Comments on #SDP-26-0005 - Planning & Zoning: Site Development Plan

Application Number: #SDP-26-0005
Application Type: Site Development Plan
Date: June 29, 2026
Address: 4502 VINEYARD PINE LN, ROLESVILLE
Parcel: 1758453022

Landscape Plan

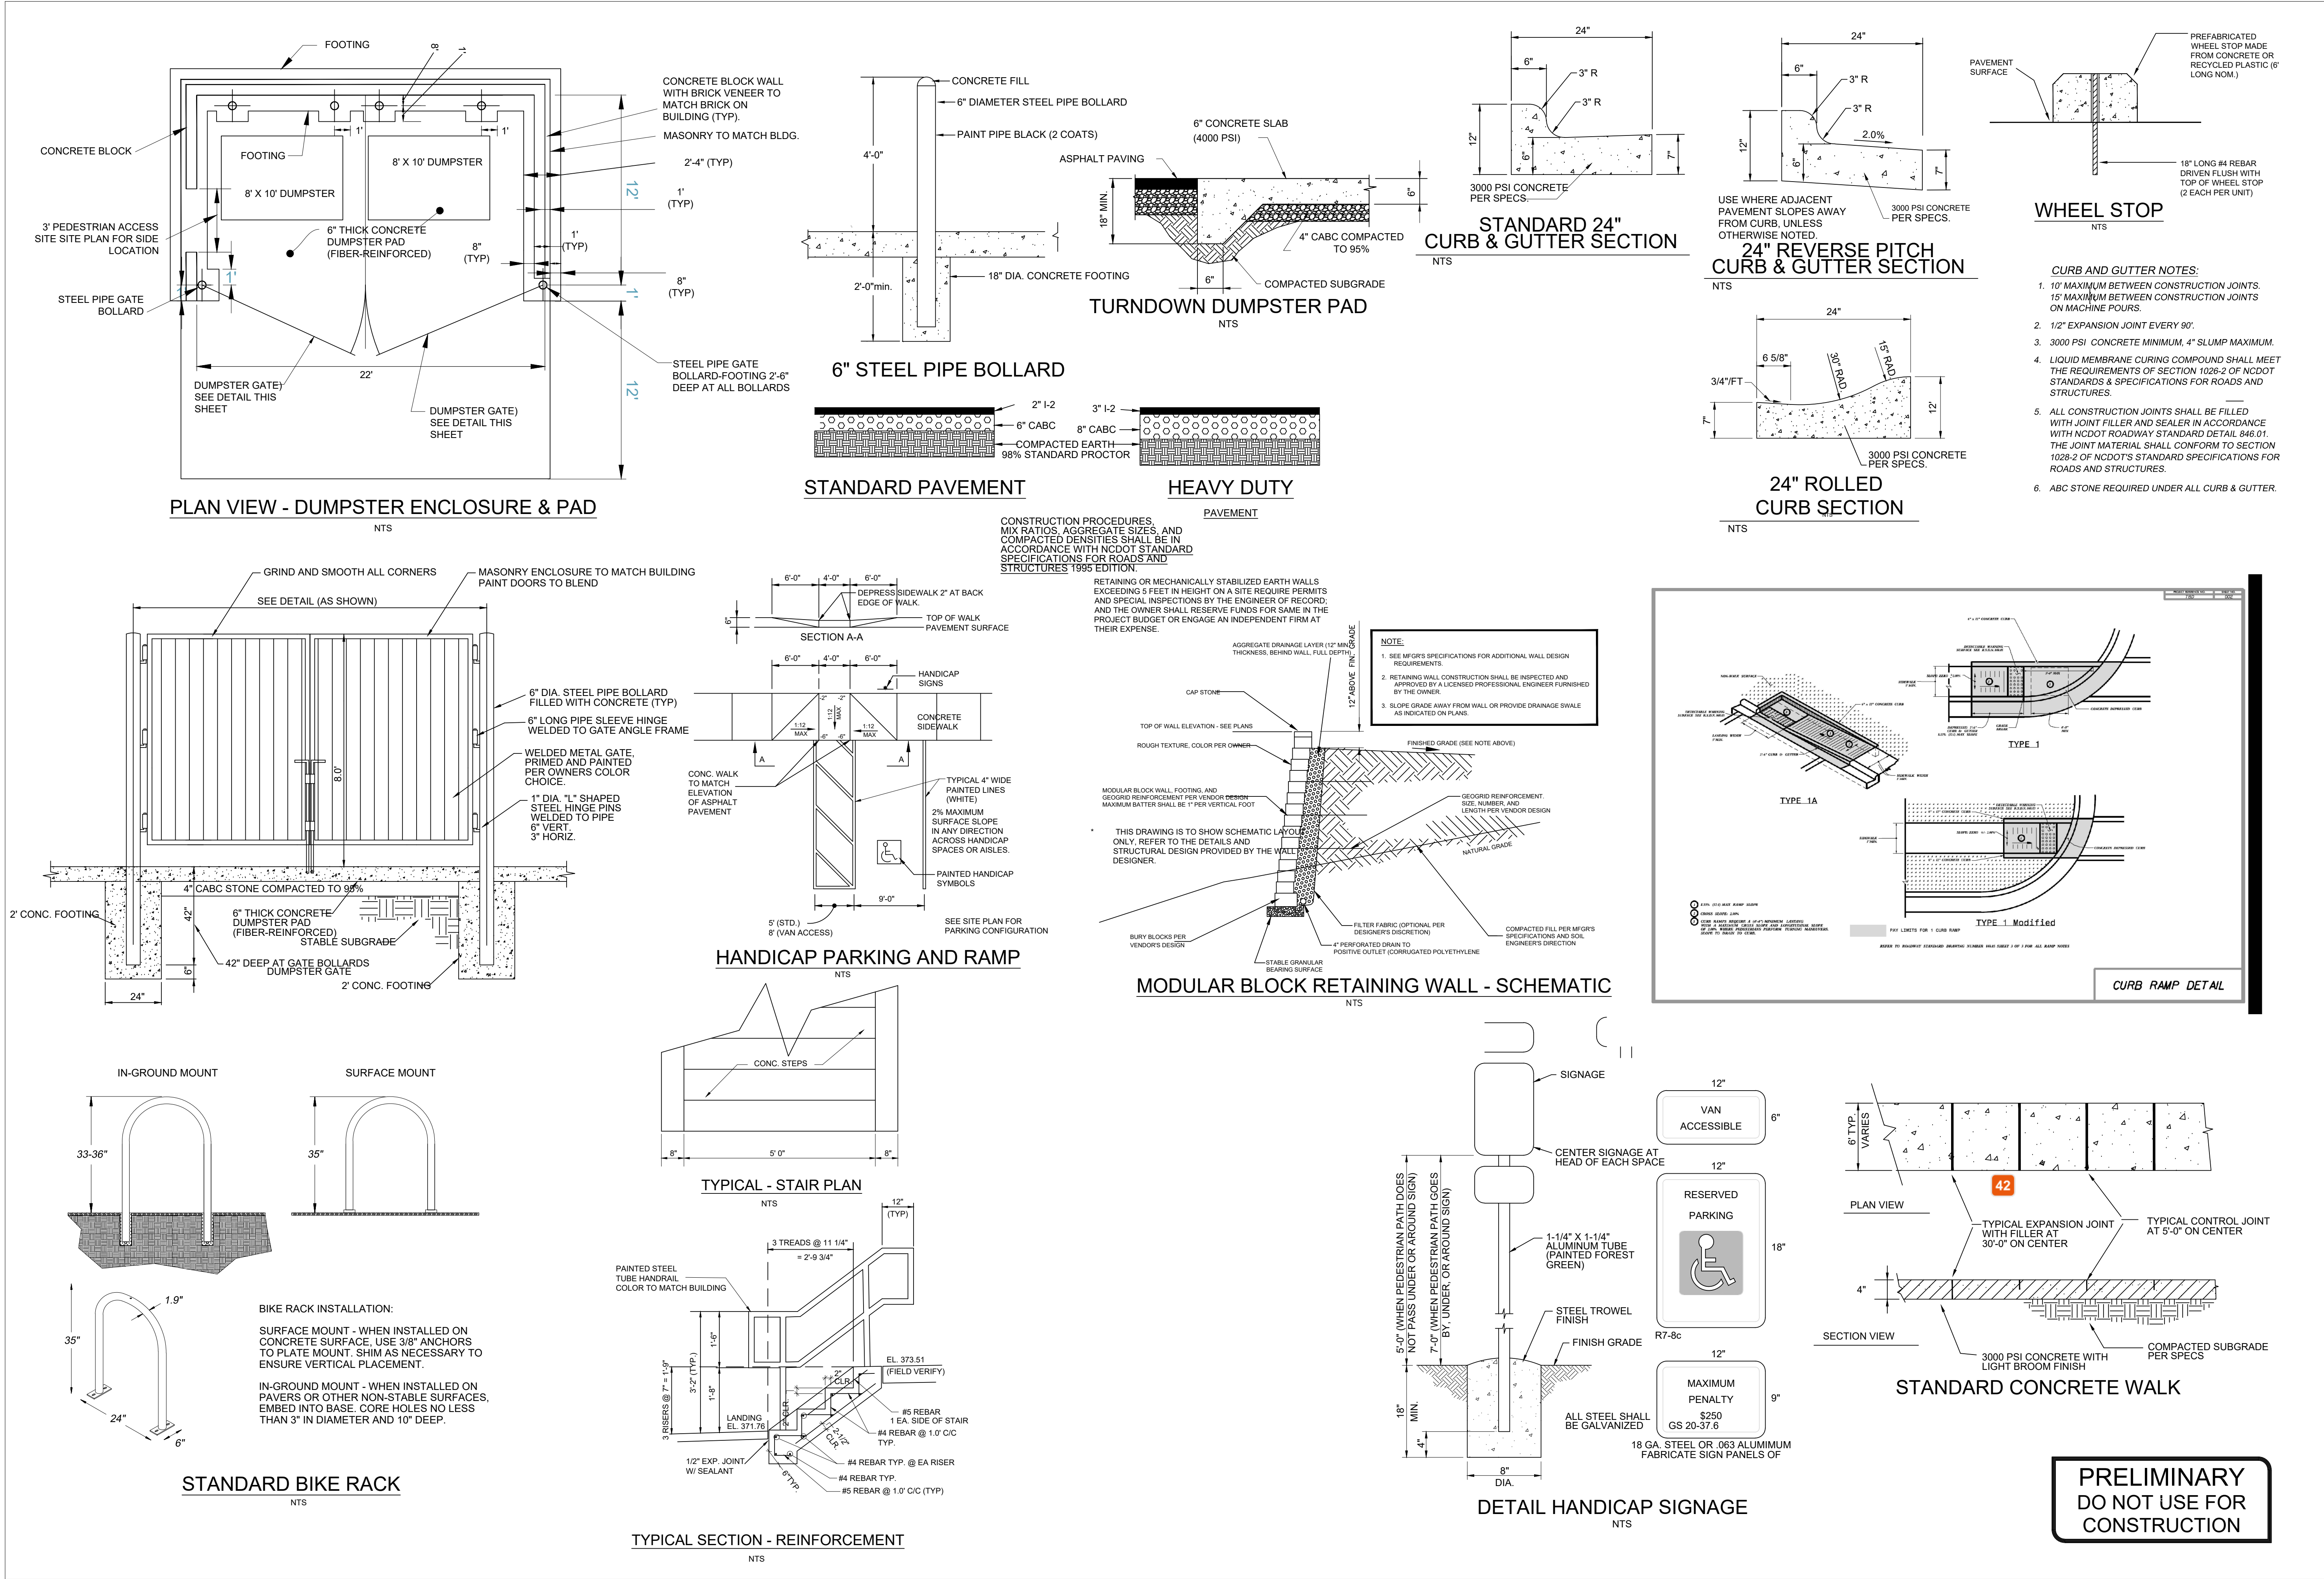
Is this a fence in the diagram? TA-26-0005 included amendments to perimeter buffers. Plant materials only may be used to meet 75% opacity. If you'd like to discuss this, let me know.

Please revise to show more of a diversity of native trees and shrubs in the landscape plan, which currently only shows one. Per Rolesville LDO 6.2.4.7c: "All developments shall provide a diverse plant palette..." Please see the following links for alternative native bush species:

Please revise landscape plan to remove *Ulmus parvifolia*, which is considered by the state to be an invasive – https://nc-ipc.weebly.com/uploads/6/8/4/6/6846349/invasive_plant_list_-_ranked_-_2023-11-16.pdf

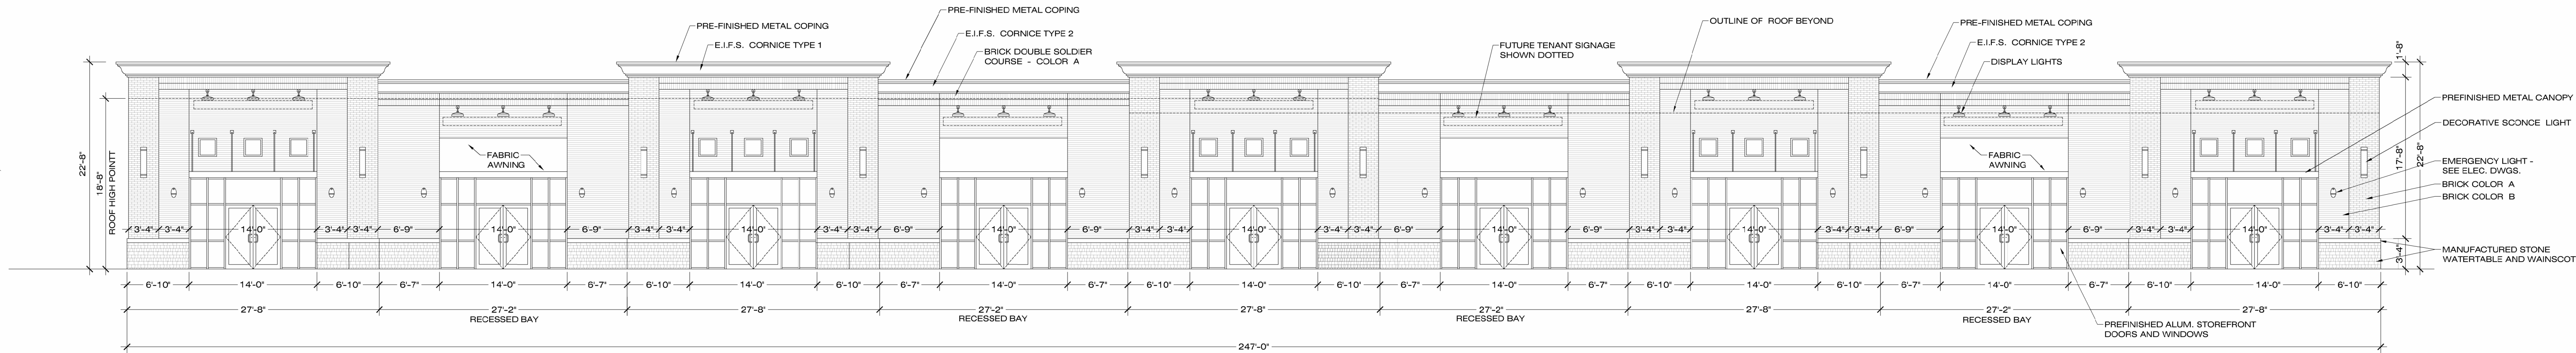
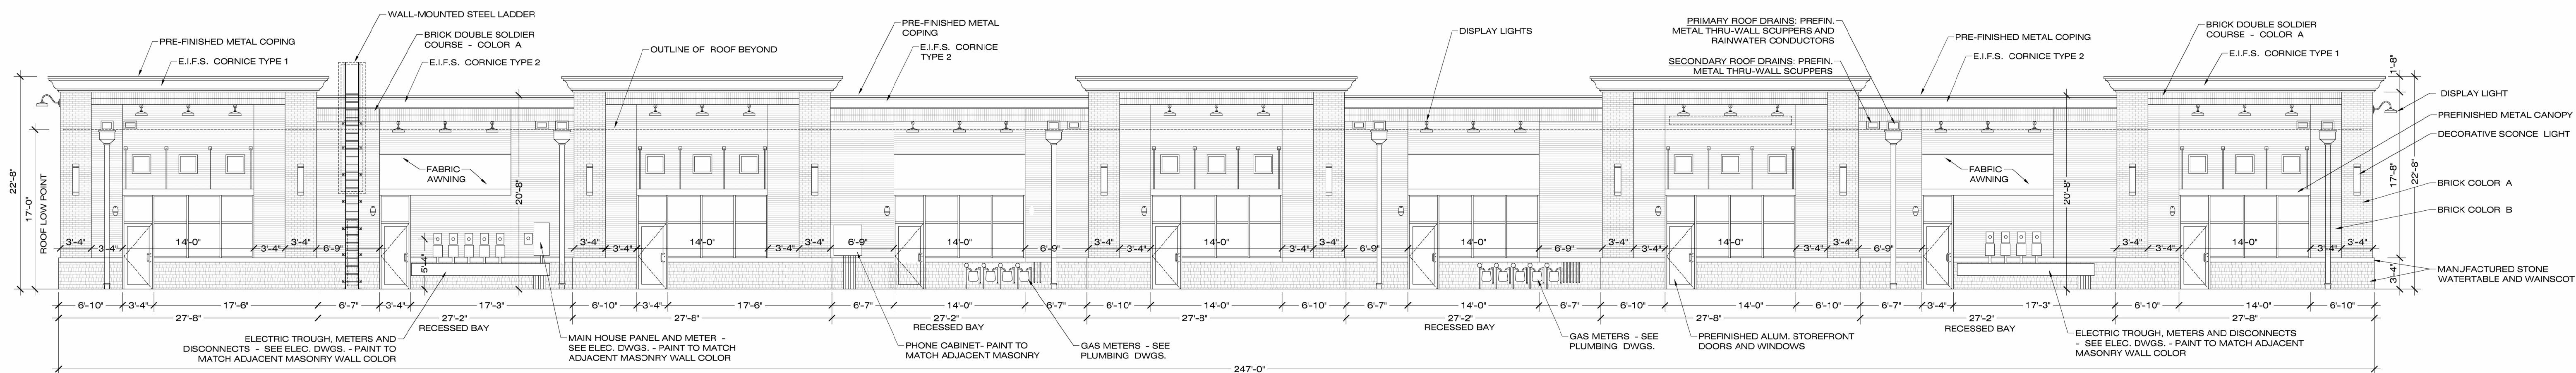
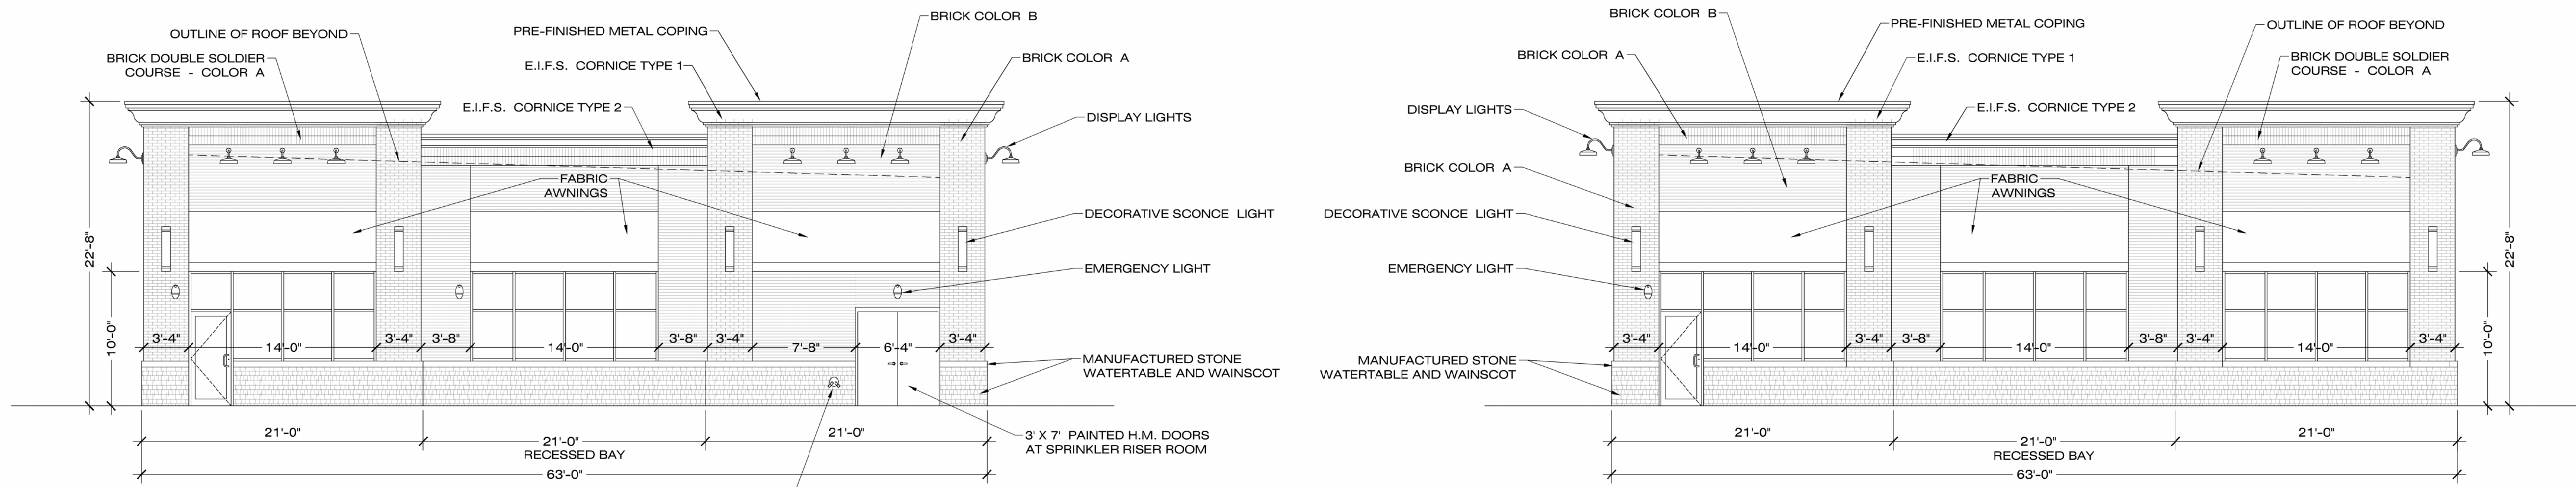
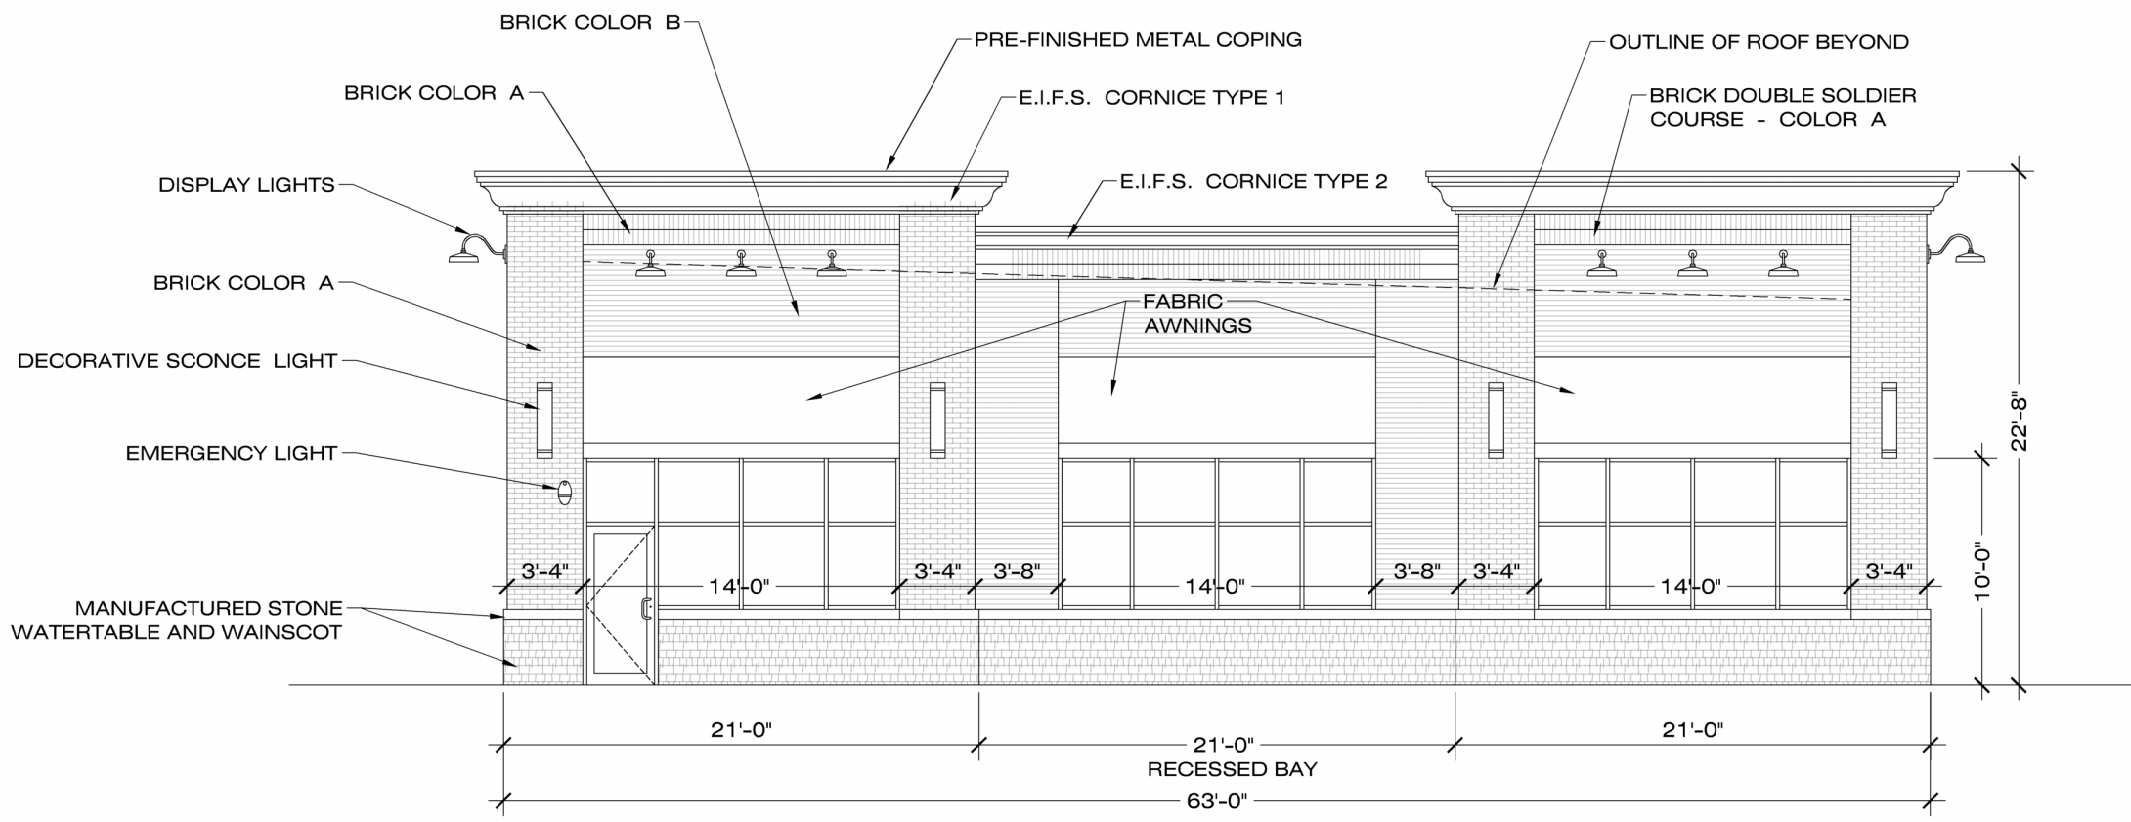
Thank you for noting compliance with transparency requirements. Please add similar notes for Facades, Building Blank Wall Area, Materials, Colors, Roof Design Standards, etc. as per LDO Section 6.8.2.D.
